Job: TCPJ10-101 Portland Jetport Expansion

Submittal Title: FIRE ALARM SHOP DRAWINGS / CALCULATIONS

Here is our reply to the comments relating to the revised FA drawings that John Hale reviewed with you last week.

DRAWN BY: L. SANTORA DATE: 06/28/10
 CHECKED BY: A. PRENTISS DATE: 07/23/10
 PROJECT NUMBER: 147-951655801
 SHEET TITLE: FIRE ALARM SYSTEM LEVEL 1 - ZONE 4
 SHEET NUMBER: **FA-102**
 FA-101_FA-103.dwg

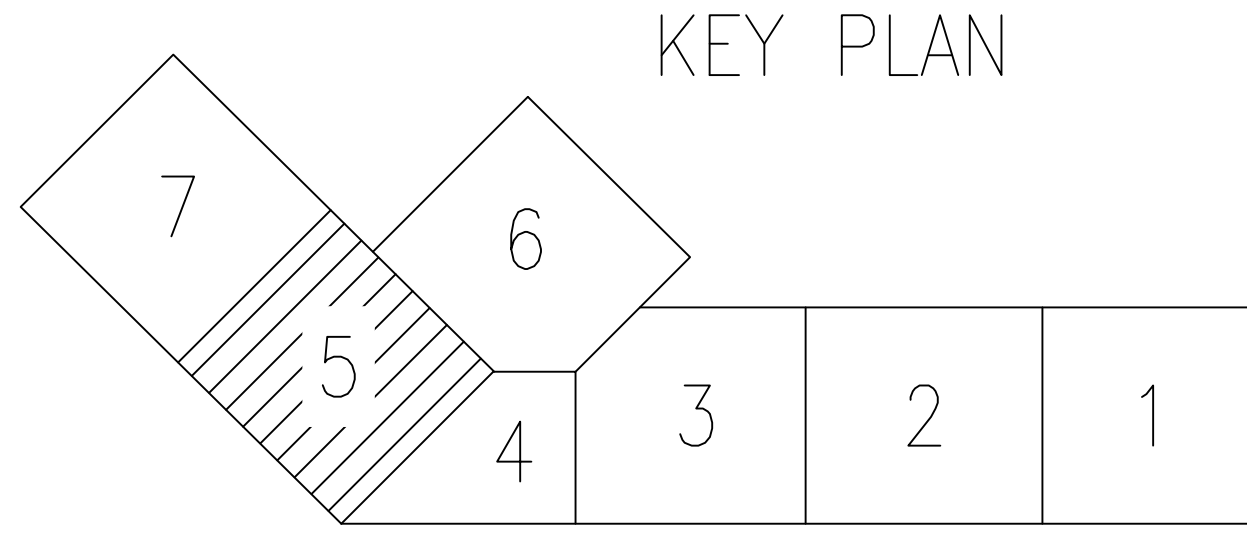
FA-102,103,107:

- Changes/corrections/modifications have been made.

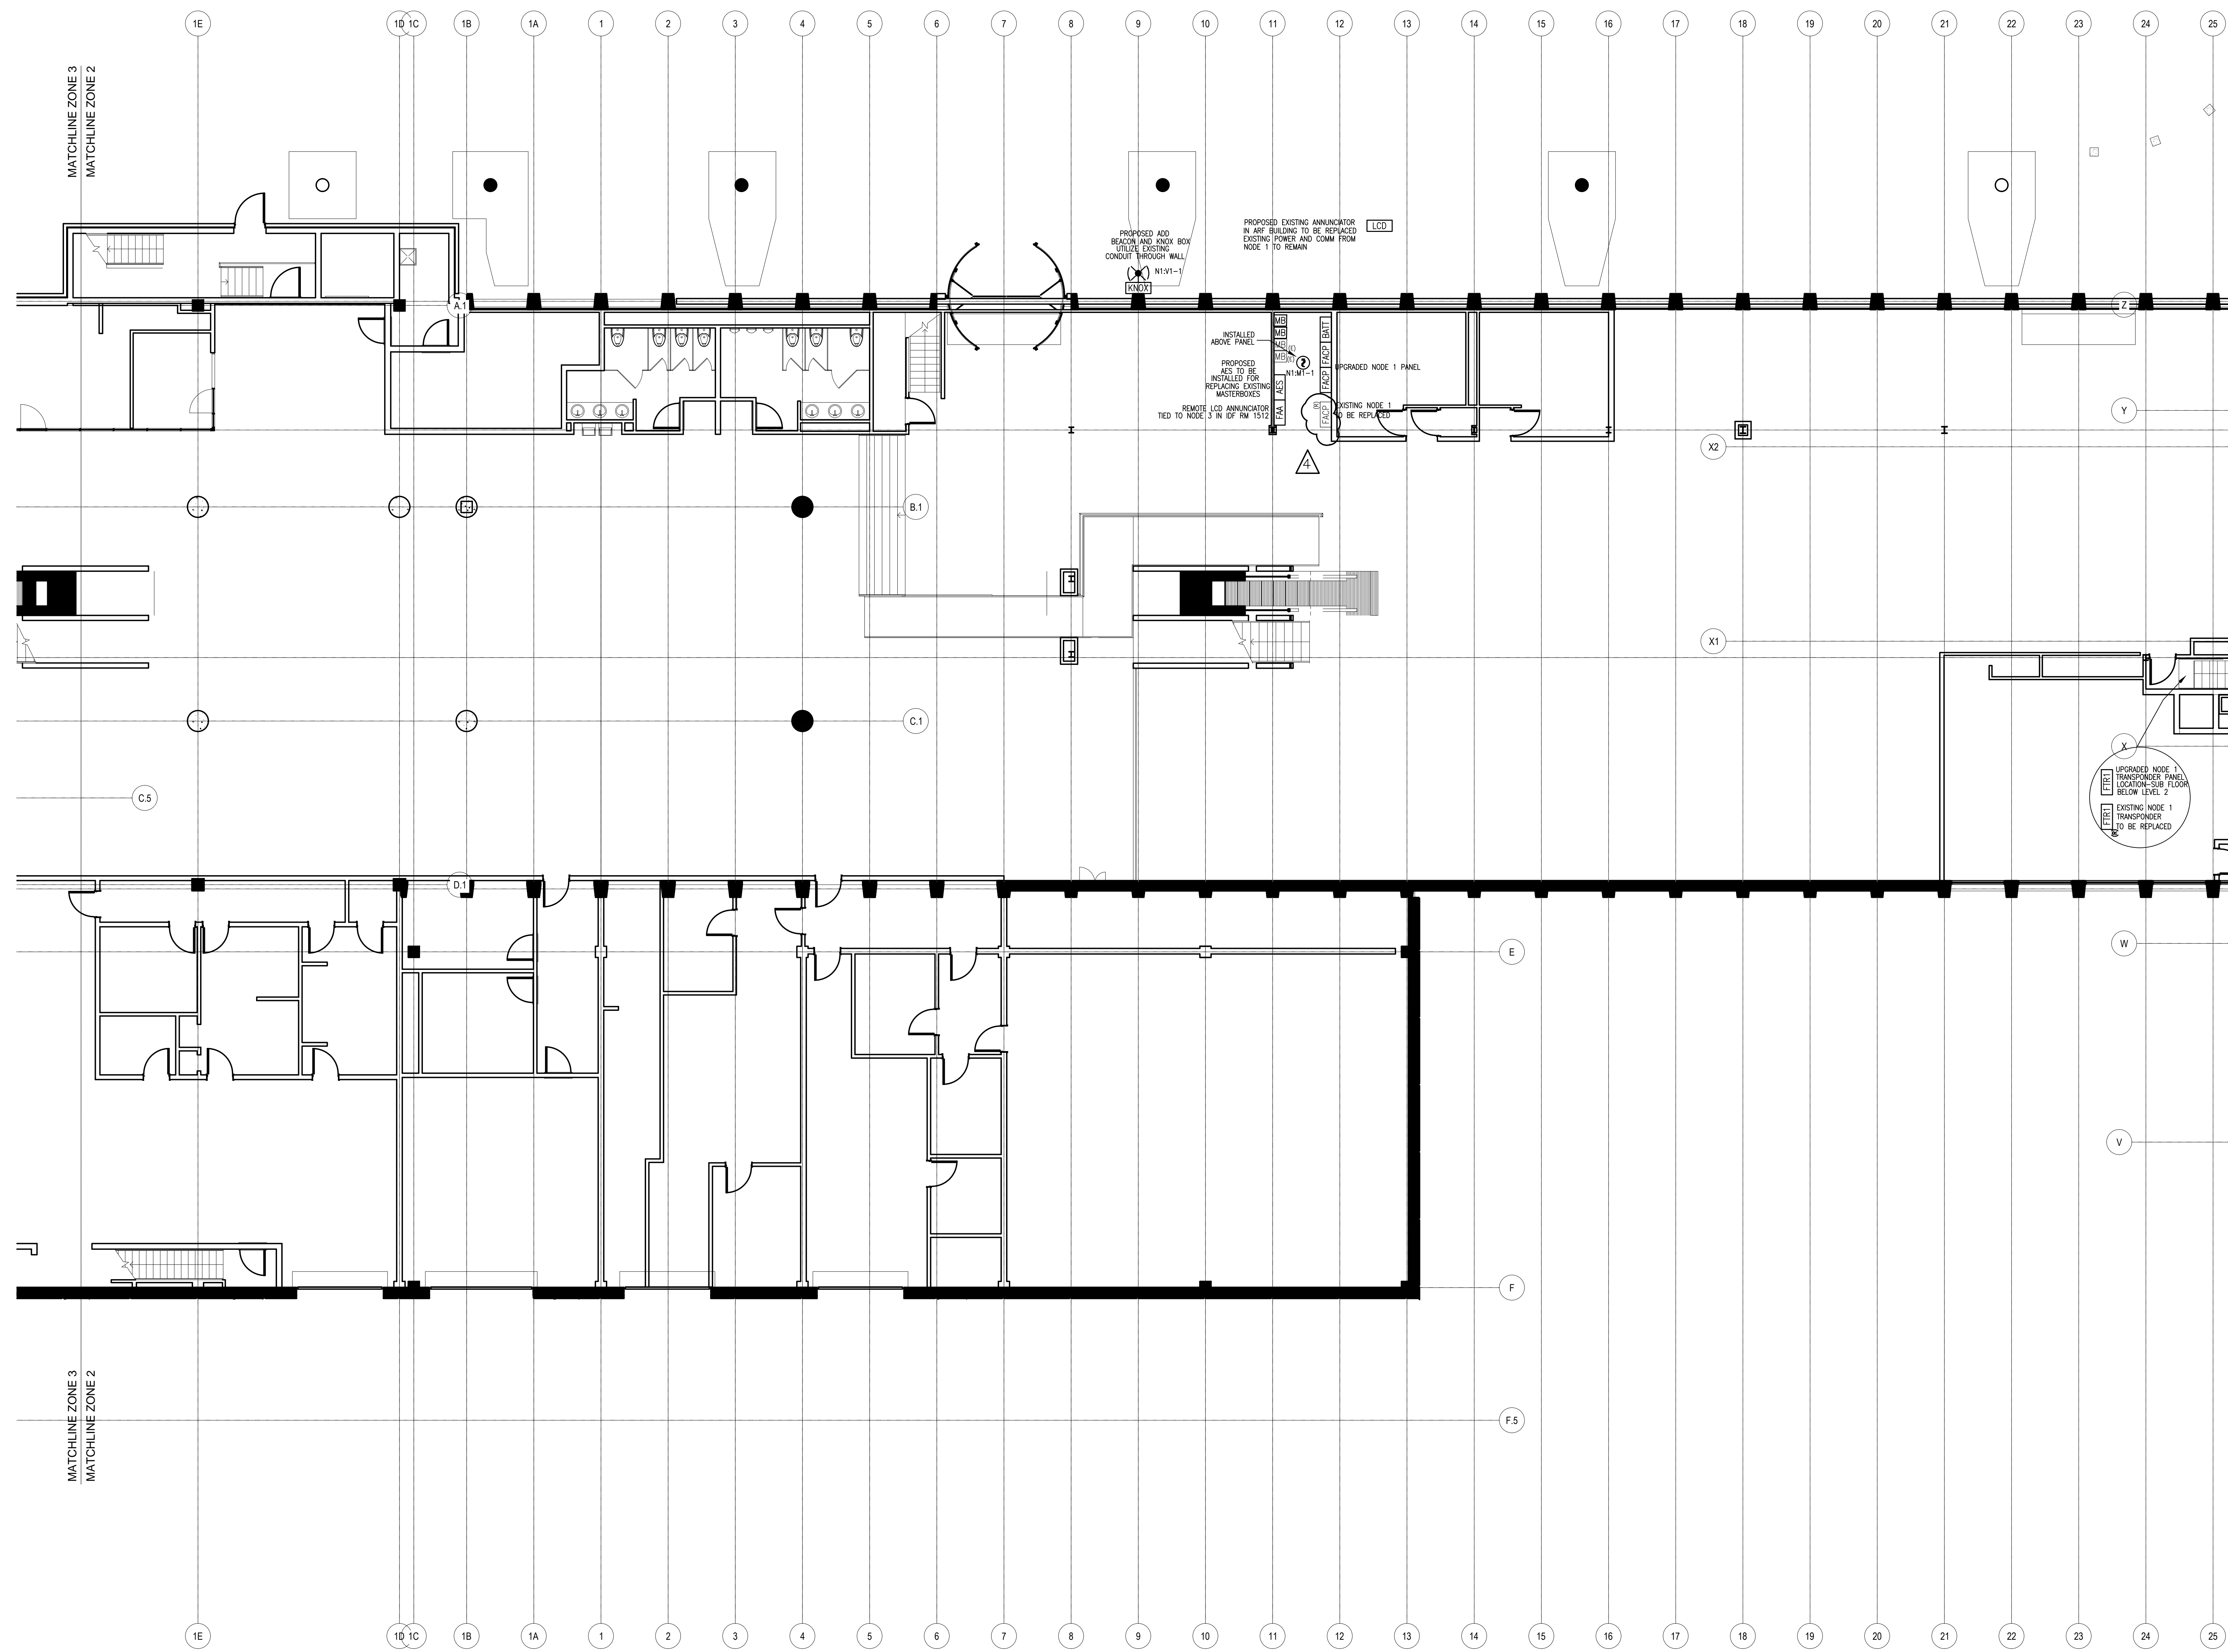
FA-104:

- Changes/corrections/modifications have been made.

DRAWN BY: L. SANTORA	DATE: 06/28/10
CHECKED BY: A. PRENTISS	DATE: 07/23/10
PROJECT NUMBER: 147-951655801	
SHEET TITLE: FIRE ALARM SYSTEM LEVEL 3 - ZONE 3	
SHEET NUMBER: FA-109

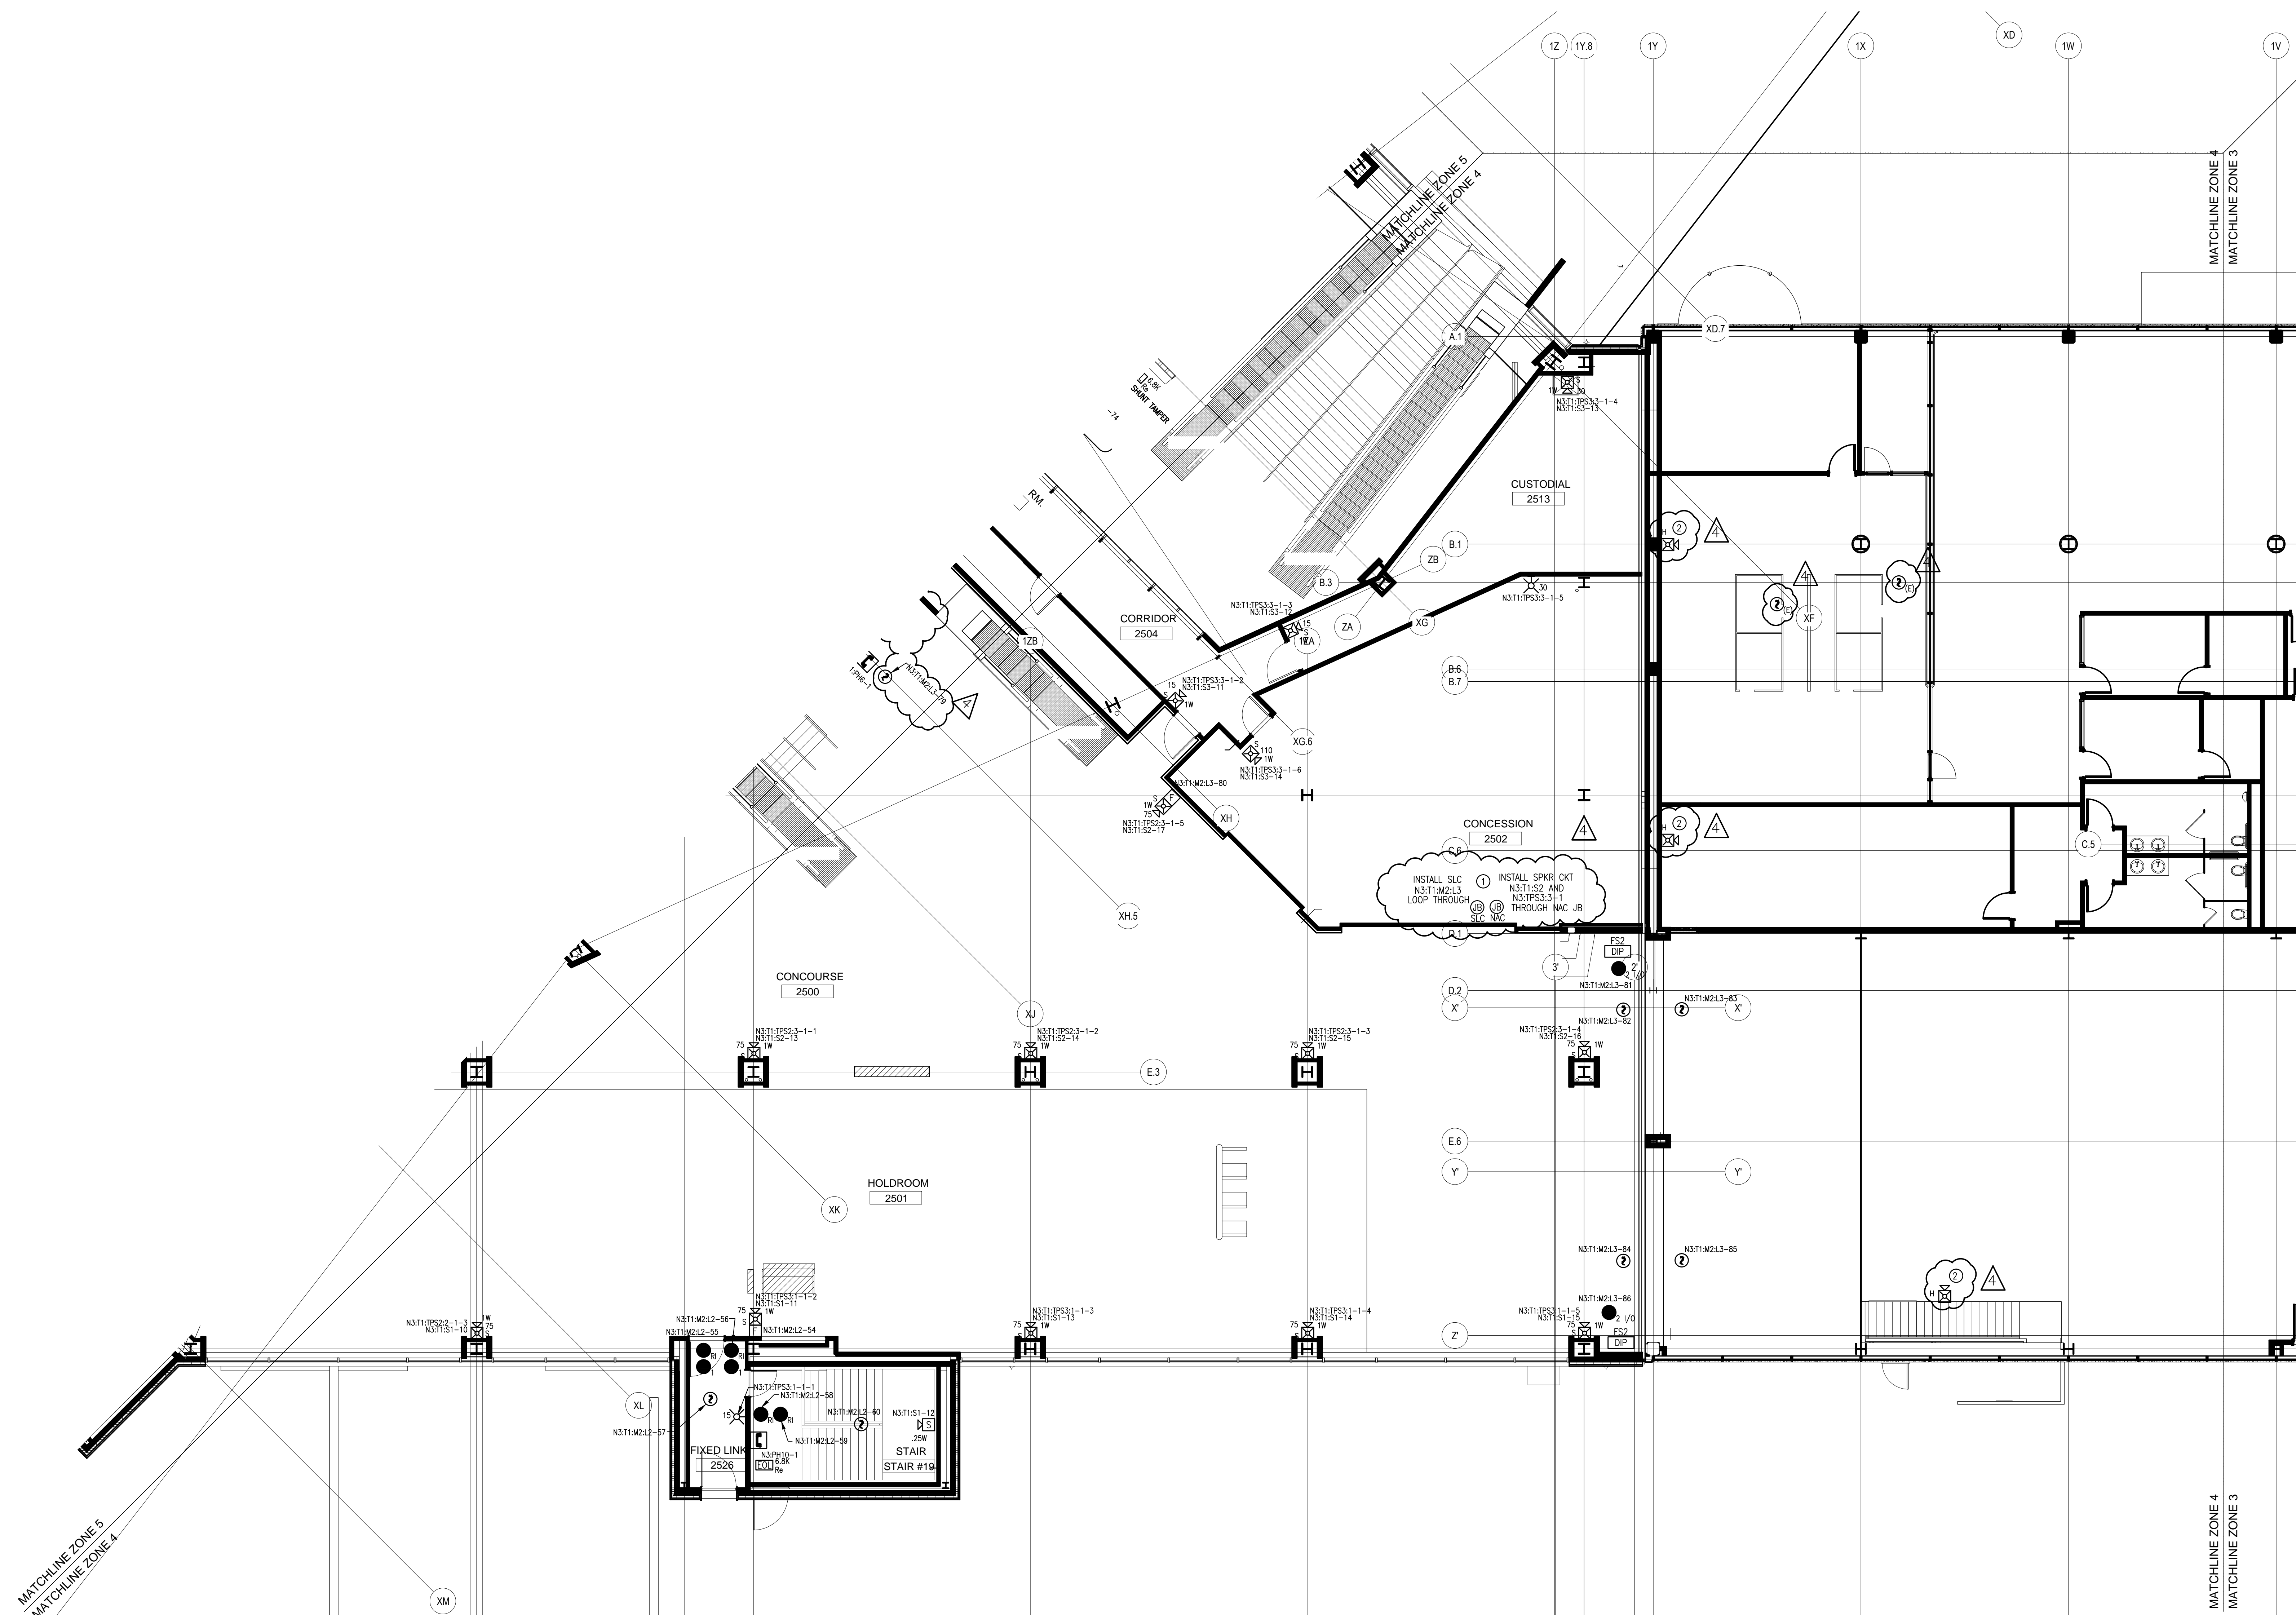
FA-109:

- Changes/corrections/modifications have been made.
